RANCH HOUSE ROAD PHASE 1 & DSRP RE-STRIPING PROJECT

PROJECT # PARKS 2022-01

1 ADDENDUM 1 - 03/02/2022

NO.	REVISION	DATE
1	ADDENDUM #1	03/02/22

OVERALL EXISTING CONDITIONS

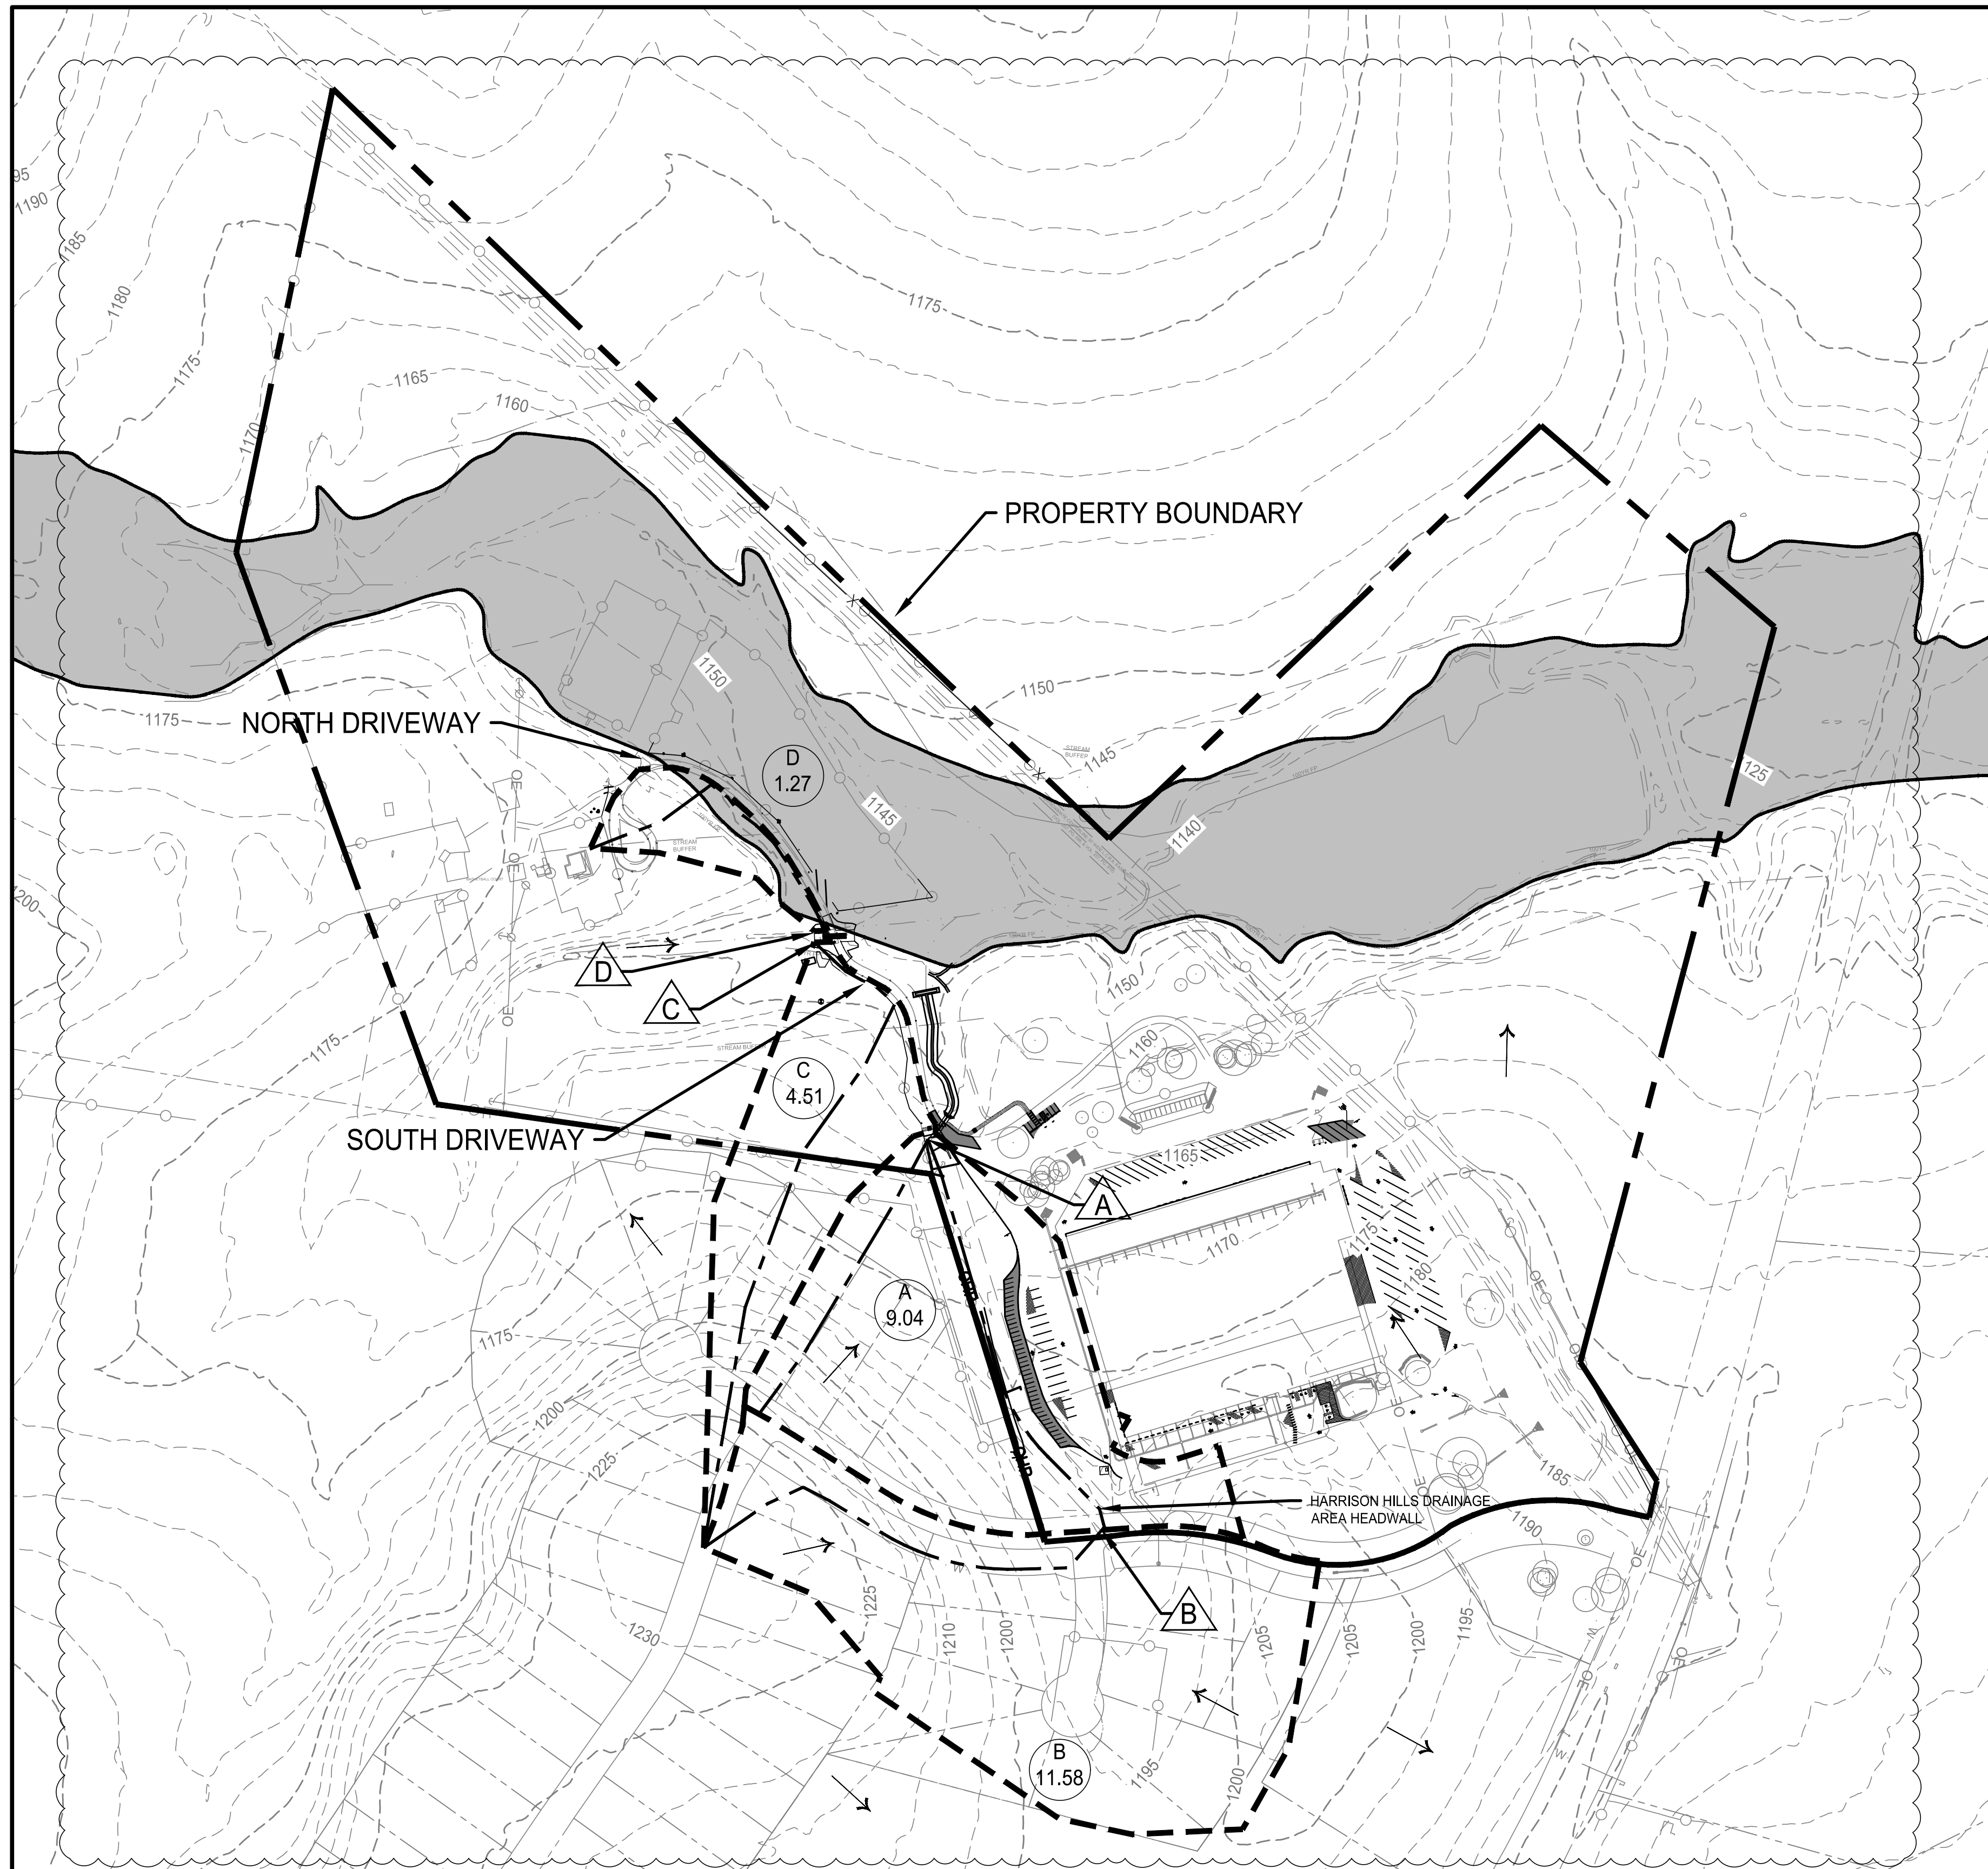
1 UPDATED PROPERTY LINE
